TOLERANCE EXCEPT AS NOTED:		MATERIAL:
3 PLACE DECIMAL: +/- .001		DWG.#: 2 REV. 2
2 PLACE DECIMAL: +/- .02	QUANTITY NEEDED:	FILENAME L16-TSV-15.ipt
FRACTIONAL: +/- 1/32	PART NO: L16-TSV-15.1	DRAWN BY: A. FREDDIE HESS
DEBUR ALL SHARP EDGES	LAFAYETTE COLLEGE ENGINEERING	SCALE: 1:2 DATE: 5/7/2015

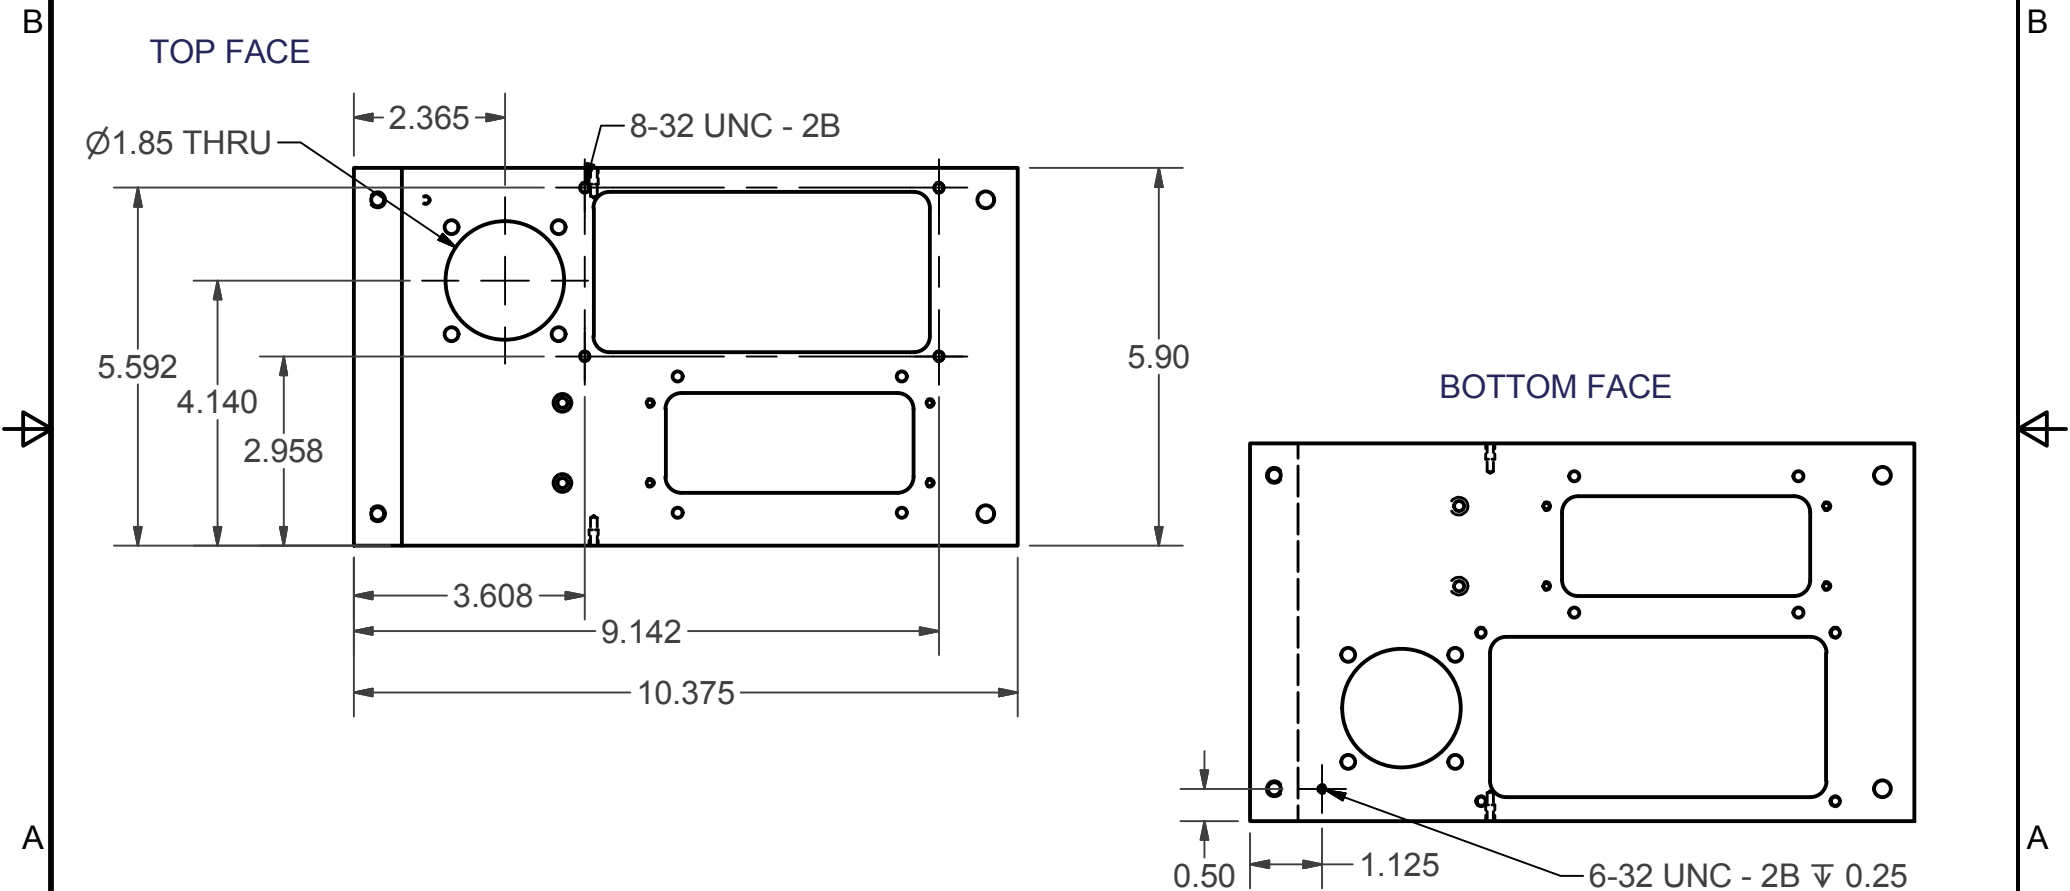
REVISIONS: -INCREASE LARGE HOLE DIAMETER FROM 1.72" TO 1.85"
 -DRILL AND TAP THRU HOLES FOR 8-32 UNF FASTENERS
 -ADDITION OF A SINGLE 6-32 FASTENER ON THE BOTTOM
 FACE OF THE PART
